APPLICATION NO.	FILING DATE	FIRST NAMED INVENTOR	ATTORNEY DOCKET NO.	CONFIRMATION NO.
10/588,579	02/01/2008	Mihai Adrian Tiberiu Sanduleanu	NL04 0105 US1	8721
65913	7590	06/19/2008		
NXP, B.V. NXP INTELLECTUAL PROPERTY DEPARTMENT M/S41-SJ 1109 MCKAY DRIVE SAN JOSE, CA 95131			EXAMINER ROJAS, DANIEL E	
			ART UNIT 2816	PAPER NUMBER
			NOTIFICATION DATE 06/19/2008	DELIVERY MODE ELECTRONIC

Office Action Summary	Application No. 10/588,579	Applicant(s) SANDULEANU ET AL.	
	Examiner DANIEL ROJAS	Art Unit 2816

DETAILED ACTION

Figure 1: Kubota's gates 16, 17, and 18 at a transistor level

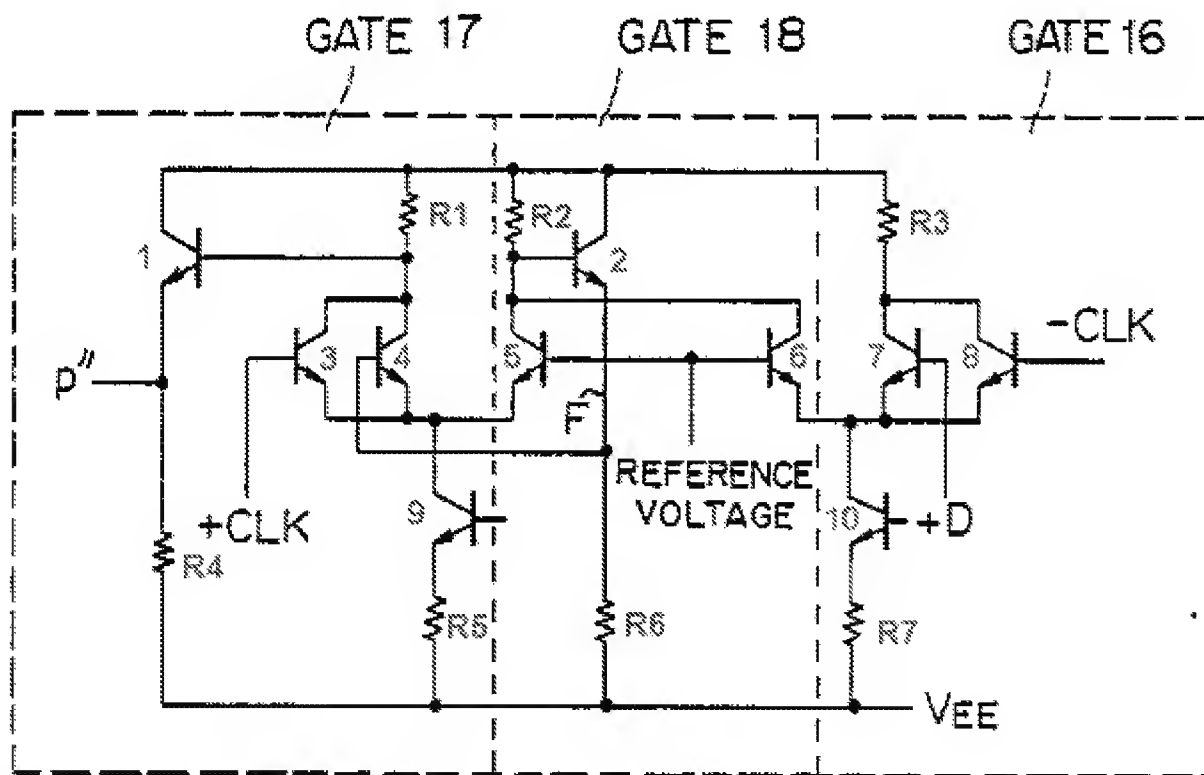
8. Claims 1-6 and 8-9 are rejected under 35 U.S.C. 103(a) as being unpatentable over Kubota (US Patent No. 4,841,168), hereinafter referred to as Kubota. Please refer to the figure below:

9. For claim 1, Kubota teaches in his Figure 5 (shown in detail in his Figure 8), a latch circuit comprising: a differential input with an inverting input (D input of 17) and a non-inverting input (input terminal of 16 connected to +D), one of the outputs (MASTER OUTPUT, which is a non-inverting output) being coupled to one of the inputs input (D-) having an opposite polarity, a control input for receiving a control signal (REFERENCE VOLTAGE, Figure 8) for determining a threshold for an input signal (D+, inherent in the structure of Figure 8) such that if the input signal is at larger than the threshold the non-inverting output in a HIGH logic state and in a LOW state if the input signal is smaller than the threshold (inherent based on the structure of Figure 8), respectively but fails to teach a differential output with an inverting output. However, examiner takes official notice that it is notoriously old and well known in the art to invert an output of a latch in order to change an active high output signal to an active low, for use with active low circuits. Therefore, it would have been obvious to one of ordinary skill in the art at the time of invention to branch off the MASTER OUTPUT signal into an inverter (i.e. a node from the MASTER OUTPUT signal being connected to the input of an inverter) in order to obtain an inverting output capable of use with active low circuits.

10. For claim 2, Kubota further teaches a latch circuit comprising transistors (as shown in Figure 8, with added numbering for reference in the figure above) the latch further comprising, a first pair of transistors comprising a first transistor (4) and a second transistor (5) having their sources coupled to each other (as shown), a second pair of transistors comprising a third transistor (6) and a fourth transistor (7) having their sources coupled to each other, a gate of the second transistor being coupled to a gate

of the third transistor (as shown) and further coupled to the control signal (REFERENCE VOLTAGE), a positive feedback from the non-inverting output (F) to a gate of the first transistor (as also shown in Kubota's Figure 5), a pair of switches comprising a first switch (3) and a second switch (8) having their respective drains and sources coupled to the respective drains and sources of the first transistor and the fourth transistor, respectively, but fails to teach that the gate of the first switch being driven by the inverting clock signal (-CLK, as explained below) and gate of the second switch being driven by the non-inverting clock signal (+CLK, as explained below). The terms "inverted" and "non-inverted" are used to describe the state of a signal (i.e. inverted or not inverted) in relation to a second signal. Therefore, since both -CLK and +CLK are clock signals, +CLK can be considered an inversion of -CLK. Examiner takes official notice that it is notoriously old and well known to replace bipolar junction transistors with MOS transistors. Therefore, it would have been obvious to one of ordinary skill in the art to replace Kubota's bipolar junction transistors with MOS transistors in order to reduce space, since MOS transistors can be manufactured much smaller than bipolar junction transistors.

11. For claim 3, Kubota further teaches that the sources of the first transistor and the second transistor are supplied by a first current source (9), the sources of the third transistor and the fourth transistor are supplied by a second current source (10).

13. For claim 5, Kubota further teaches that the drain of the first transistor and the drain of the fourth transistor are coupled to each other and further coupled to a supply voltage (VEE) via a first resistor means (R6).

14. For claim 6, Kubota further teaches that the drain of the second transistor (5) is coupled to a drain of the third transistor (6), the drains being further coupled to the supply voltage (V_{EE}) via a second resistor means (R2).

15. For claim 8, Kubota teaches a first current source (9), a second current source (10) which receive a reference signal via their respective gates and a third resistor means (R5 and R7) but fails to teach a series connection of a main current channel of a current source. It is notoriously old and well known that if multiple nodes are receiving a reference signal of equal voltage, the said multiple nodes can be connected to a single reference voltage source. Therefore, it would have been obvious to one of ordinary skill in the art at the time of invention to have Kubota's first and second current source (9 and 10, respectively) connected to the same reference voltage source since it has been held that discovering an optimum value of a result effective variable involves only routine skill in the art. In re Boesch, 617 F .2d 272, 205 USPQ 215 (CCPA 1980).

16. For claim 9, it is inherent for a transistor to be controlled by a voltage applied to its gate. Therefore, the first and second current sources (9 and 10, respectively) are controlled by a voltage.
